RE: Permit No. M-1980-244; Cripple Creek & Victor Gold Mining Company; Cresson Project; Preliminary Adequacy Review Response to Technical Revision 130 – Stormwater Improvements

On February 11, 2022, Newmont Corporation's Cripple Creek and Victor Gold Mining Company (CC&V) received the Division of Reclamation, Mining, and Safety (DRMS) adequacy review of Technical Revision (TR) 130 to Permit M-1980-244, proposing improvements to stormwater controls. Below are DRMS comments in **bold** followed by CC&V's responses in *italics*.

PIPELINE PLAN AND PROFILE

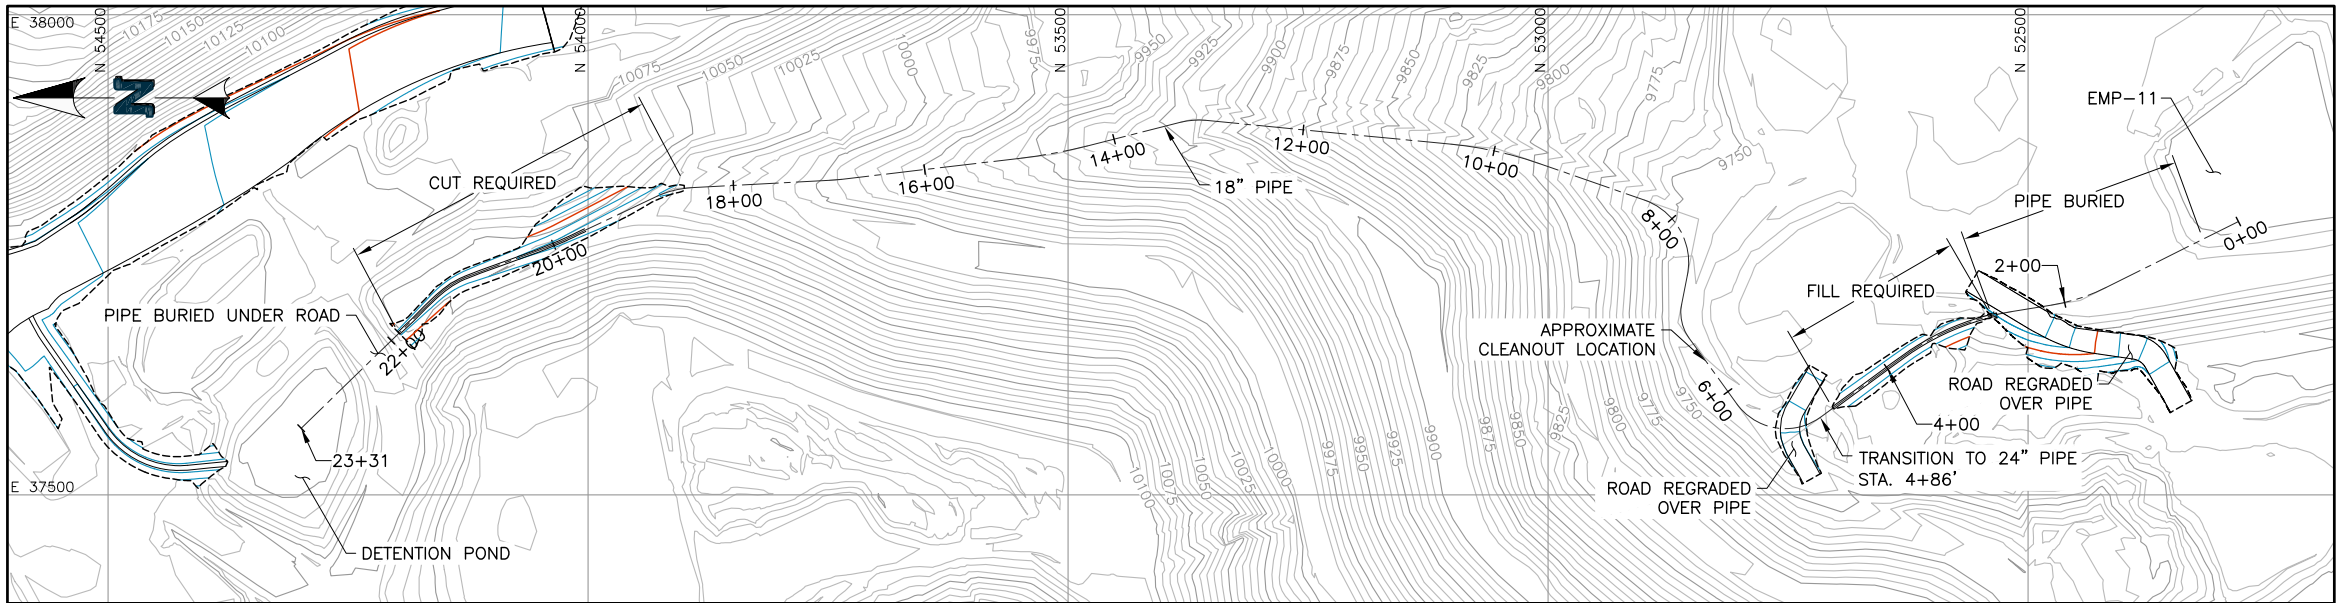
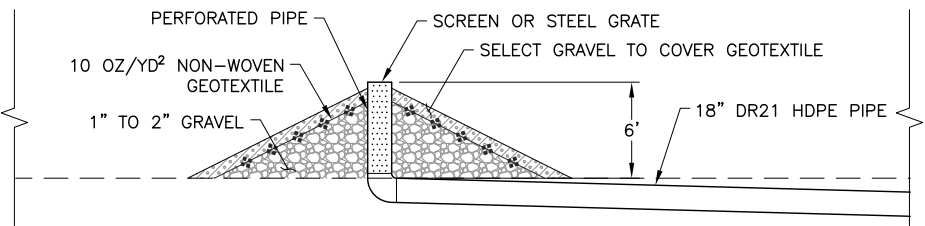
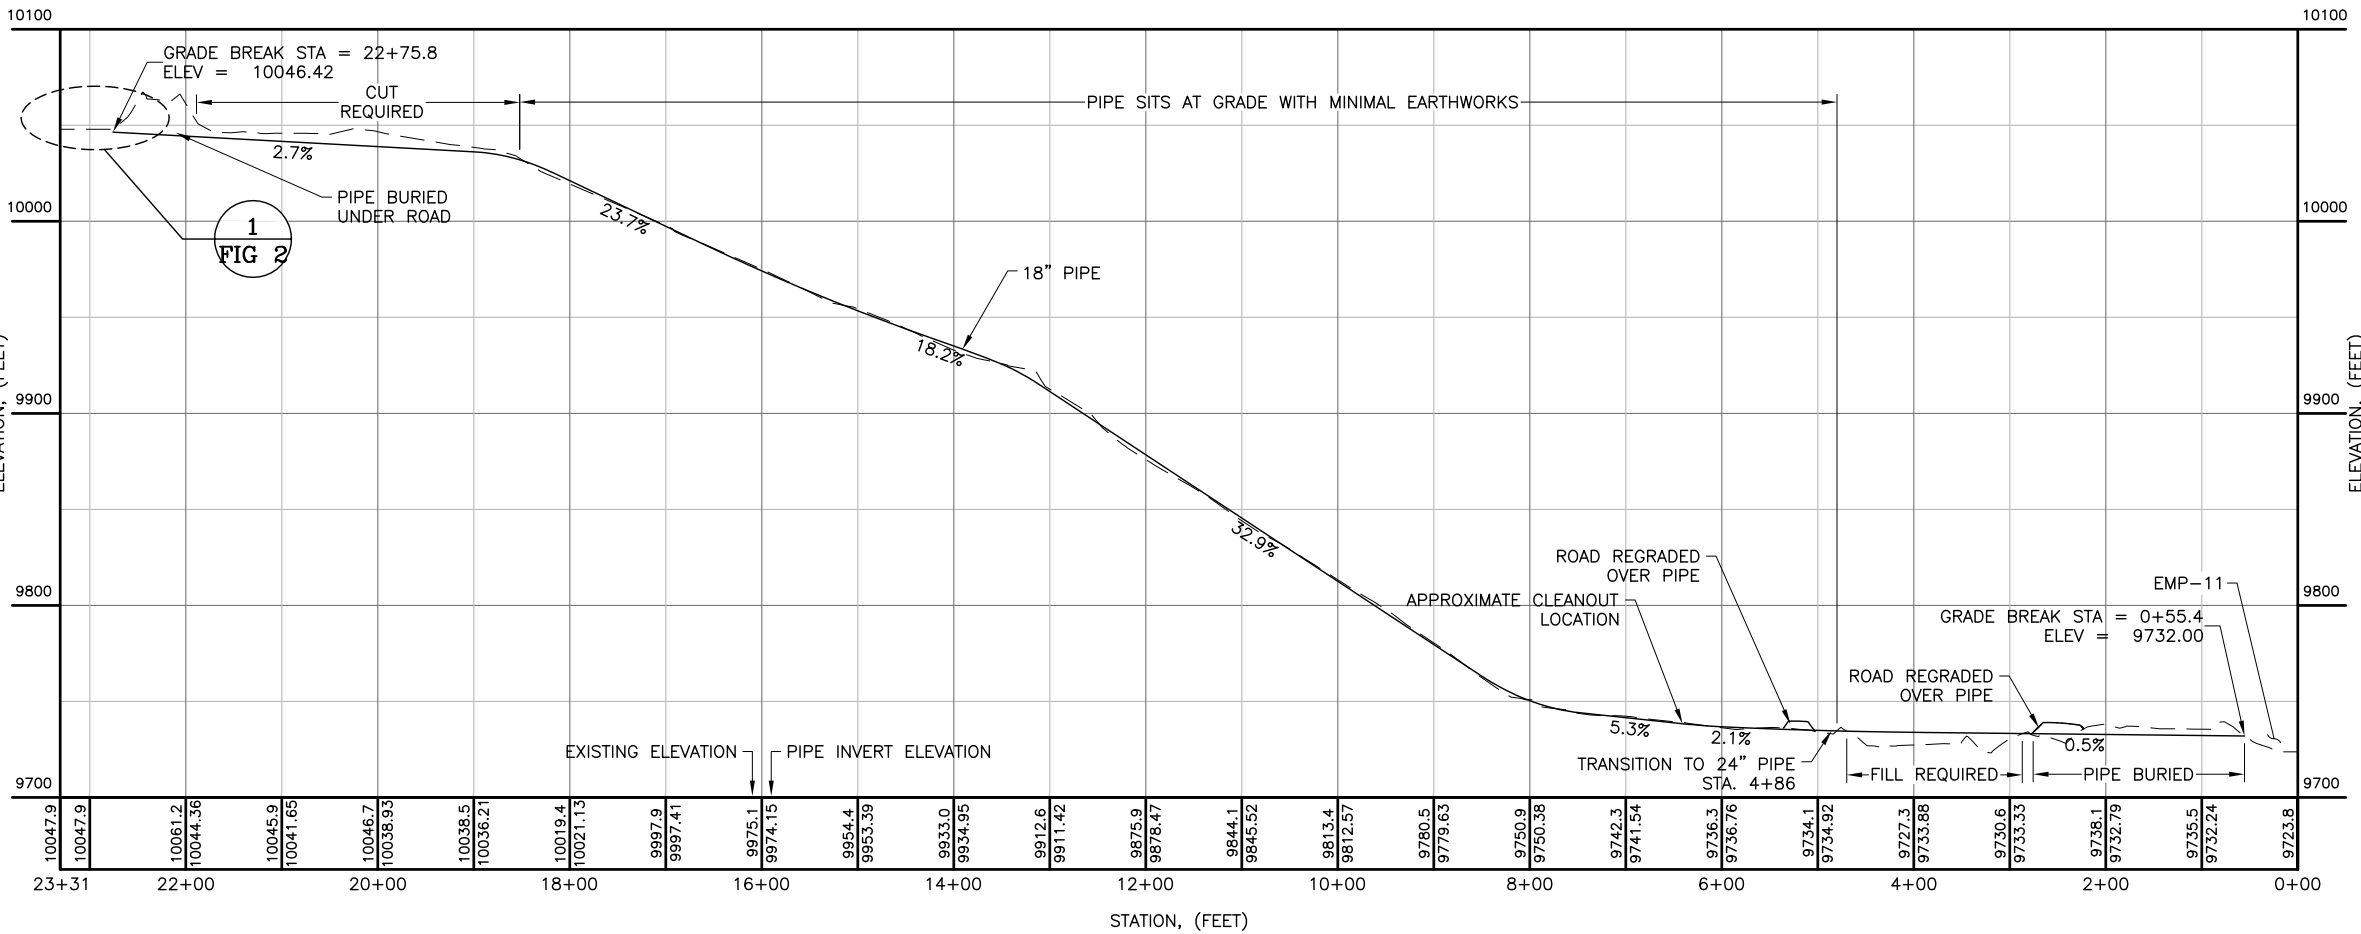
- 7) **Existing Depression Retention Pond:** Figure 2 indicates the depression just south of the LOB will be used as a retention pond, yet there is 2,331 feet of HDPE pipe proposed to convey flows to EMP-11. Additionally, the HEC-HMS schematic on the "Watershed Flow Calculations" sheet suggests gravity flow. Is water to be pumped into the HDPE pipe, or is it gravity flow? If its gravity flow, this would be a detention pond and means to limit sediment into the HDPE pipe need to be implemented to reduce the potential for lower flows to deposit sediment into the pipes flat sections, leading to a plugged pipe. If this is truly a retention pond, it will retain

a. Is the discharge pumped or gravity flow?

b. If gravity flow, how will sediment be restricted from entering the 2,331 feet of pipe?

a. Provide consistent documentation on the length of pipe proposed.

b. Provide a profile of the proposed pipe between the LOB depression and EMP-11.

d. Describe how maintenance/sediment removal will be performed on the long pipe.

The entire system will flow by gravity; no pumping is anticipated. Figure 2 shows the pipeline profile, starting at the depression that will be used as a detention pond (incorrectly labeled as a "retention" pond in TR130).

Sediment will be restricted using a perforated riser pipe surrounded by gravel and geotextile. Figure 2 shows a schematic of the perforated riser pipe intake.

The information presented in the attachments of TR130 showed only the steepest and shallowest pipe sections for sizing purposes. The table below presents all pipe segments and Figure 2 shows the corresponding pipe profile. Please note that the data shown in the revised table differs from that shown in TR130, as the perforated pipe intake structure was incorporated into the HEC-HMS model.

Figure 2 (attached) shows the proposed pipe plan and profile. Please note that no fittings are proposed to achieve vertical and horizontal bends; directional changes will be achieved using the allowable pipe bend radius of 27 times the outside diameter of the pipe, or 40.5 feet for 18-inch diameter pipe and 54 feet for 24-inch diameter pipe (minimum).

The pipe is anticipated to be self-cleaning, but a cleanout has been incorporated as shown near Station 6+50 on Figure 2 as a precautionary measure. Additional cleanouts may be installed as

PROJECT		CLIENT	
STORMWATER IMPROVEMENTS		CRIPPLE CREEK & VICTOR GOLD MINING COMPANY	
TITLE		FILENAME	
VLF 1 LINER SECTION		0106.054.007F	
		FIGURE NO.	REVISION
		3	A

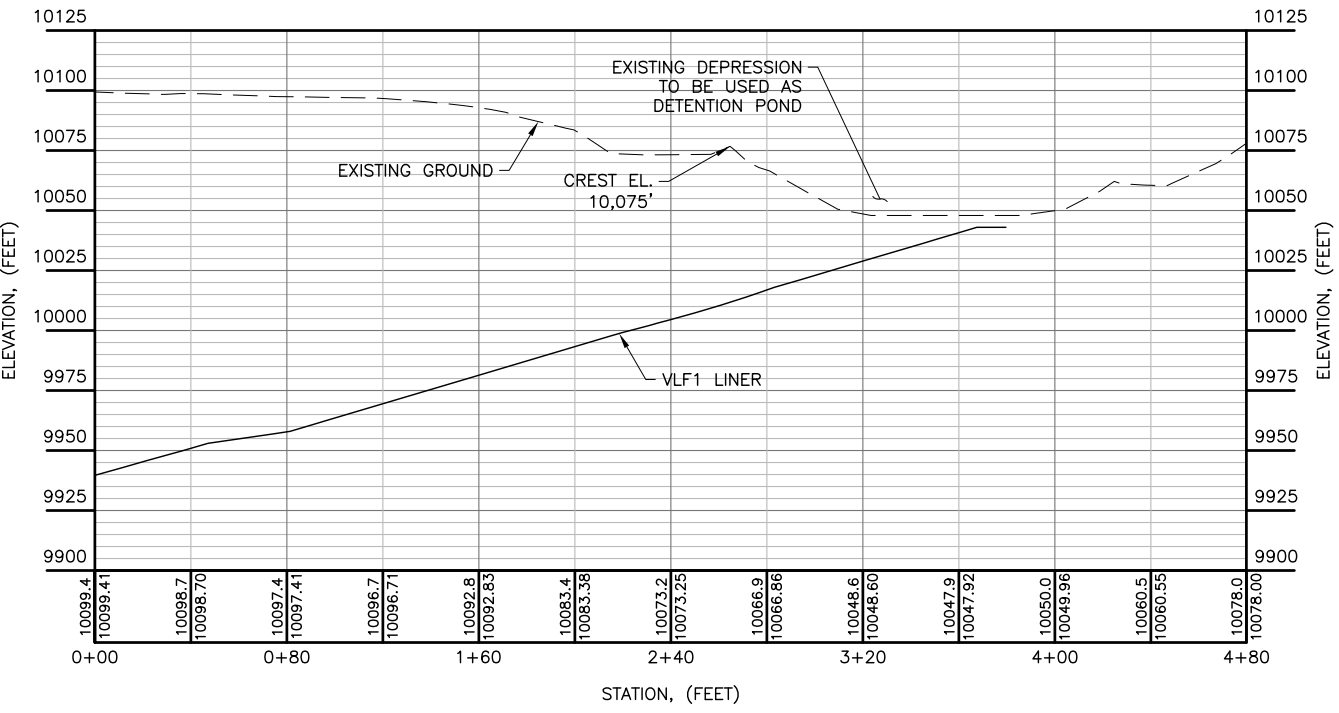
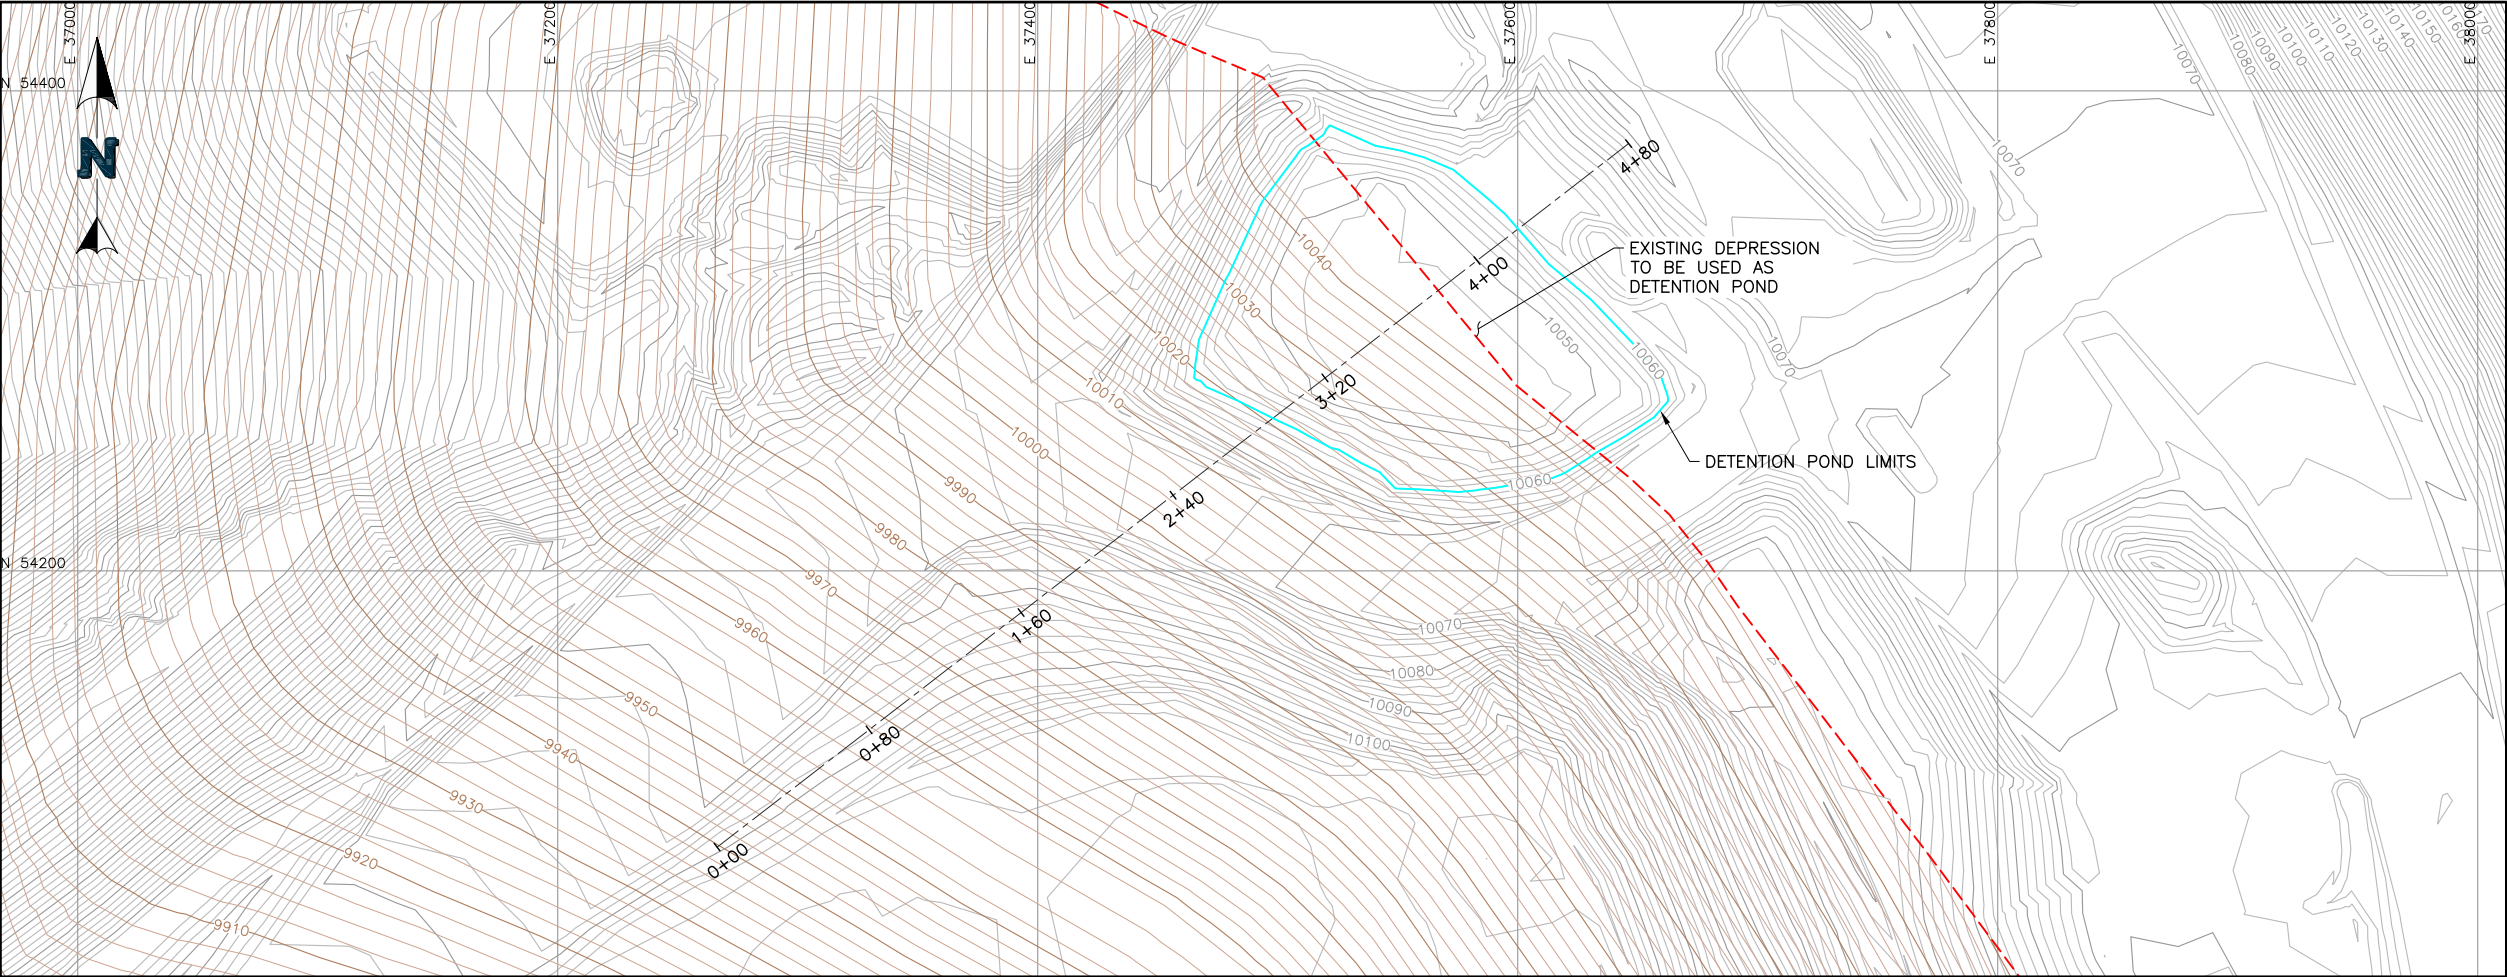
a mixture of non-contact water from the native hillside and contact water from the LOB and VLF1 over a shallow liner, thereby limiting the infiltration rate and may take quite some time to pump out (no demonstration is made of the depression's storage capacity). As this depression is proposed to receive more runoff than it currently does, and will receive some contact water, it is a potential wildlife attractant. Please address the following:

Additionally, all water reporting to this depression is anticipated to be non-contact water. Although the LOB and a portion of the depression are underlain with geomembrane liner, no process solution has been applied to the overlying fill materials or materials being transported at or around the LOB. Figure 3 shows the depression area with the geomembrane liner subgrade, showing how the VLF1 lined subgrade drains away from the pond.
